# COMMITTEE OF ADJUSTMENT

## MINOR VARIANCE REPORT

APPLICATION: **CAV A/061/2024**

**CAV A/061/2024 - 153 Ulster Drive (West District) (OP Designation: Low Density Residential)**

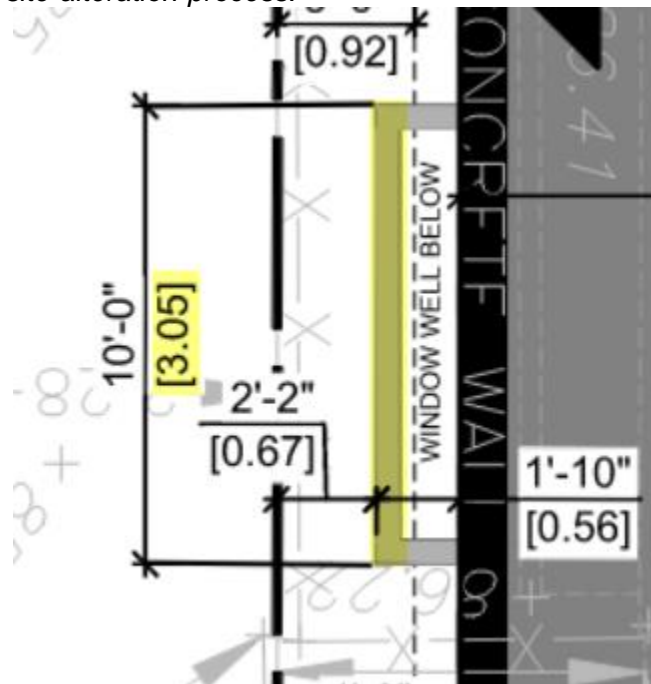
**Variance #1** – Window Well Encroachment (No Objection) – window well width of 1.8 m encroaching 0.6 m into a minimum yard, increased to a window well width of 3.05 m encroaching into a minimum yard

The intent of regulating window wells is to allow for adequate drainage and passage through a yard so that the window well does not impede access and to allow for adequate open space and landscaping. In this instance, the window well will not impede access and adequate landscaping will be accommodated on-site. Drainage will continue to occur; however, as part of the building permit submission of detailed engineering plans (Grading Plans) will be required to address concerns raised from Development Engineering and ensure no offsite drainage impacts.

**Note:** *Development Engineering does not support the increased window well size as this will make it more difficult to facilitate drainage between the lots. Additionally, Development Engineering notes that the increase in hardened surface from the development will add to cumulative impact downstream. As such, additional runoff mitigation measures should be considered during the site alteration process.*
